Report: TAB Report
Function: Test, Adjust, & Balance
Date: 01/30/2026
Completed By: National TAB

PROJECT
03-23-26 WAWA #7219 LIMA, OH

Table Of Contents

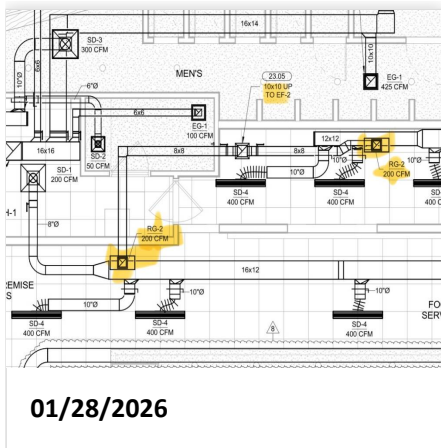
Issue Name : EF-2 LOW FLOW
Description : EF-2 is exhausting 120cfm out of 400cfm required by design. Low exhaust grille readings likely due to detached ductwork pictured.
Created By : National TAB **Assigned To :** National TAB - Noah Stafford
Status : Closed
Priority : High **Asset Tag :**
Originated Date : 01/29/2026 - Noah Stafford - National TAB

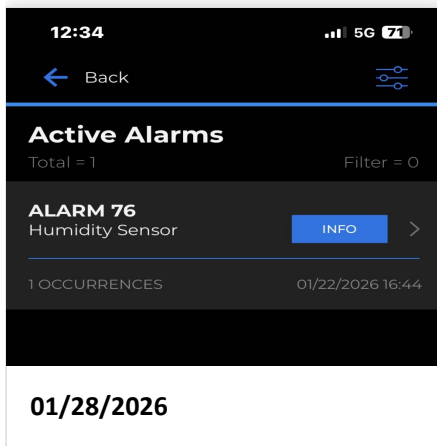
Issue Name : EF-3 POWER
Description : EF-3 is not wired. TAB cannot be completed until resolved.
Created By : National TAB **Assigned To :** National TAB - Noah Stafford
Status : Closed
Priority : Urgent **Asset Tag :**
Originated Date : 01/27/2026 - Noah Stafford - National TAB

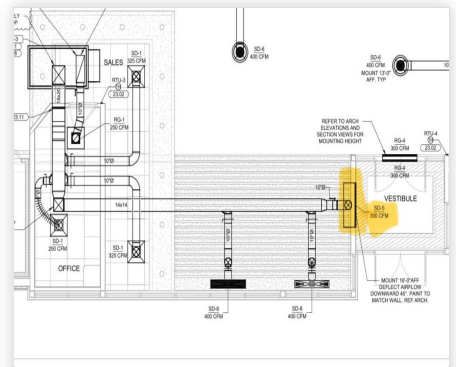
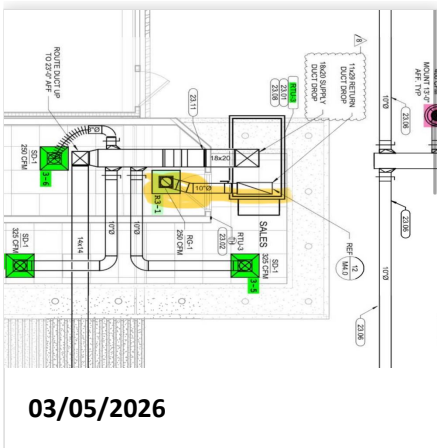
Issue Name : RTU-3 MISSING DIFFUSER
Description : RTU-3 is missing diffuser 3-1 at the main entrance vestibule. TAB cannot be completed until installed.
Created By : National TAB **Assigned To :** National TAB - Noah Stafford
Status : Closed
Priority : Urgent **Asset Tag :**
Originated Date : 01/28/2026 - Noah Stafford - National TAB

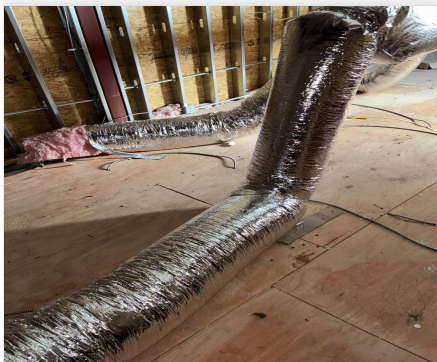
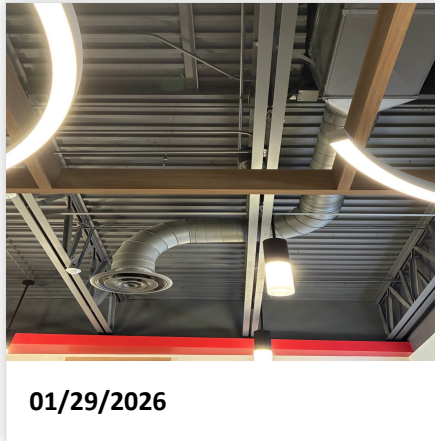
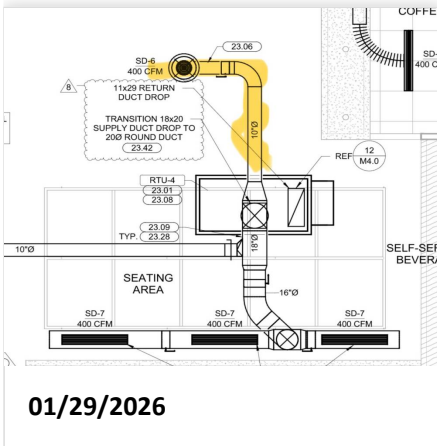
Issue Name : RTU-3 VESTIBULE DIFFUSER
Description : The linear vestibule diffuser on RTU-3 is receiving 72% of design airflow. Possibly caused by oval opening on the back of the diffuser not fitting to larger circular flex duct, causing restriction. Update 3/25/2026: Flex duct secured to back of diffuser. Airflow into diffuser confirmed to be in design via traverse.
Created By : National TAB **Assigned To :** National TAB - Noah Stafford
Status : Closed
Priority : High **Asset Tag :**
Originated Date : 03/05/2026 - Noah Stafford - National TAB
